Access Compliance Report

Public Rights-of-Way

Intersection ID: 27720	Main Street: OLD_ACRES_CT	Cross Street: HAMPSHIRE_HILL_RD	Location: SW
ADA ID: 0624DD07B1B5	Ramp Type: BlendTrans1	Initial Pass/Fail: Pass	Overall Compliance: No
		Severity Score: 0.25

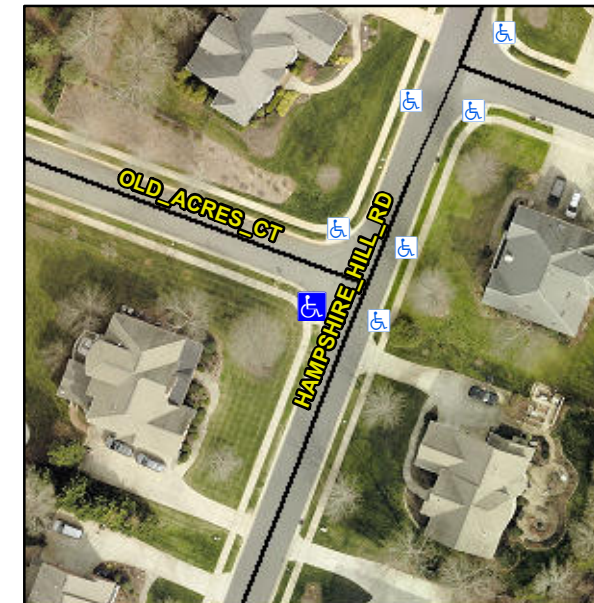
Not Found, R304.5.3, R304.2.2-Perp, R304.3.2-Para, R305.2

Compliance	Description	Data	Compliance	Description	Data
N/A	Ramp Length (in)	50.0	Yes	BlendTrans Slope (%)	4.2
Yes	Ramp Width (in)	56.0	No	BlendTrans XSlope (%)	2.6
N/A	Flare Type LT	Sloped	N/A	Flare Type RT	Sloped
N/A	Flare Slope LT (%)	0.3	N/A	Flare Slope RT (%)	2.7
N/A	Flare Traversable LT?	No	N/A	Flare Traversable RT?	No
Yes	Landing Length (in)	50.0	Yes	DWS Provided?	Yes
Yes	Landing Width (in)	56.0	Yes	DWS Contrast?	Yes
No	Landing Slope (%)	2.1	Yes	DWS Length (in)	24.0
No	Landing X Slope (%)	2.4	Yes	DWS Full Width?	Yes
N/A	Landing Curb? (Y/N)	No	No	DWS Offset (in)	8.0
N/A	Shared Landing?	No			
Yes	Gutter Ponding?	No	Yes	Gutter Slope (%)	0.6
Yes	Gutter Lip Ht (in)	0.0	Yes	Gutter X Slope (%)	1.1
N/A	Painted X Walk1?	No	N/A	Painted X Walk2?	No
	X Walk 1 Direction	To SE		X Walk 2 Direction	To NE
	X Walk 1 Width (in)	N/A		X Walk 2 Width (in)	N/A
	X Walk 1 Slope (%)	3.8		X Walk 2 Slope (%)	5.9
	X Walk 1 X Slope (%)	5.8		X Walk 2 X Slope (%)	1.7

Remove & Replace Curb Ramp With Two New Directional Ramps or Equivalent.
